QUALITY ASSURANCE -- NON-CONFORMANCE REPORT

Location: Changxing Island **Report No:** NCR-000362
Prime Contractor: American Bridge/Fluor Enterprises, a JV **Date:** 08-Jul-2009
Submitting Contractor: Zhenhua Port Machinery Company, Ltd (ZPMC), Changxing Island **NCR #:** ZPMC-0336

Reference Description: Missed UT and MT indications

Job Name: SAS Superstructure
Document No: 05.03.06-000315

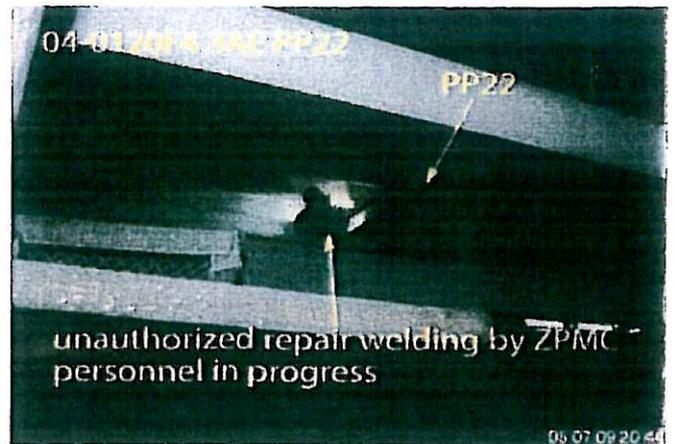
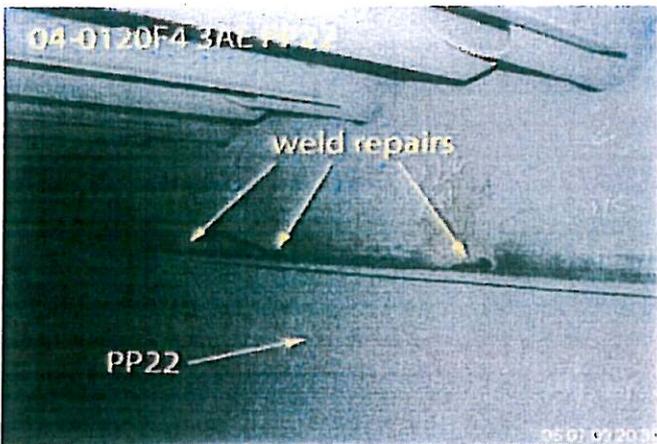
- Caltrans Quality Assurance (QA) Inspector performed Magnetic Particle Testing (MT) on Weld Joint SEG015A-007 (Side Plate to Bottom Plate) and Longitudinal Diaphragm (LD) between Panel Point 22 and 23 located in Segment 3BW. QA Inspector also performed the MT on Panel Point 23 vertical surface area where the LD fits up. The QA Inspector observed several linear indications approximately 130mm in length. ZPMC MT Technician performed the MT testing at same area after and concurred with the QA Inspector findings.

- Caltrans Quality Assurance (QA) Inspector performed Ultrasonic Testing (UT) verification on weld joint SEG015A-007 (Side Plate to Bottom Plate). The tested area was located between Panel Point 22 and 23 in Segment 3BW. QA Inspector discovered sixteen (16) class "A", "B" and "C" rejectable indication measuring approximately 480 mm in total in length. The weld seam that was inspected is approximately 4300mm in length.
 The first linear discontinuity is located at 1100mm from Panel Point 23. The last measurable linearity discontinuity was located at 4270mm from Panel Point 23.

Draft of Welding Discontinuity:

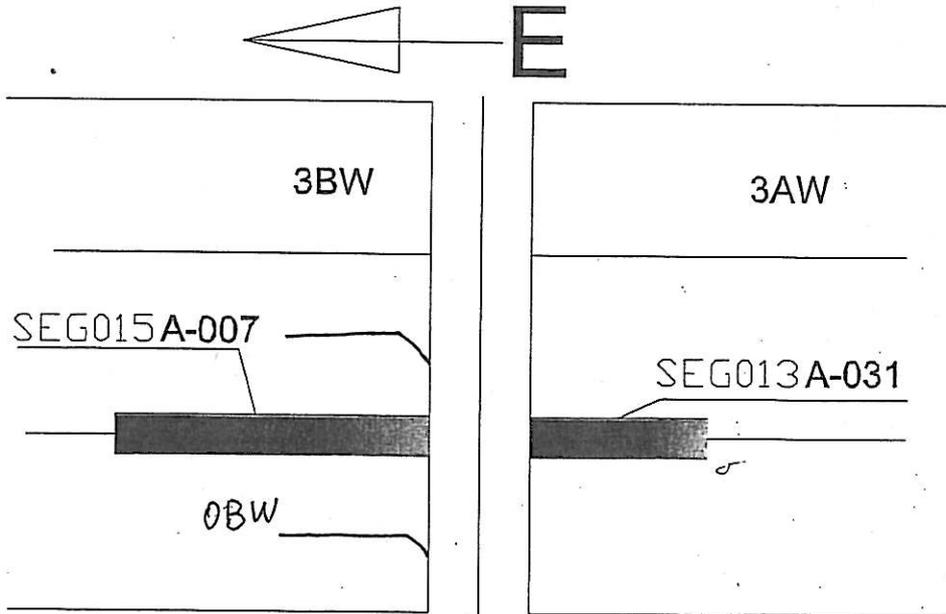
经检查发现3AW与3BW北侧底板与斜底板拐角处对接缝错边最大10.5mm, 错边总长约5000mm. 详见下图, 其焊缝编号分别为SEG013A-031, SEG015A-007(现状态焊接已冲砂)

The misalignment was maximum 10.5mm at north bottom plate and side plate, 5000mm in length, relevant welds No.: SEG013A-031, SEG015A-007, and has finished welding and shading, the detail see the following draft.

1. Remove the welds between side plates and bottom plate at the splice. Preheat according to the WPS prior to gouging.
2. Adjust the misalignment and the straightness to meet the tolerance by outer force.
3. Prepare the excavation between side plate and bottom plate according to the relevant WPS.
4. Perform 100%VT and MT inspection to the groove to ensure no defects exist; ;
5. Preheat and weld according to the WPS.
6. Grind the weld flush to the adjacent weld or base metal.
7. Check the weld according to the shop drawings.
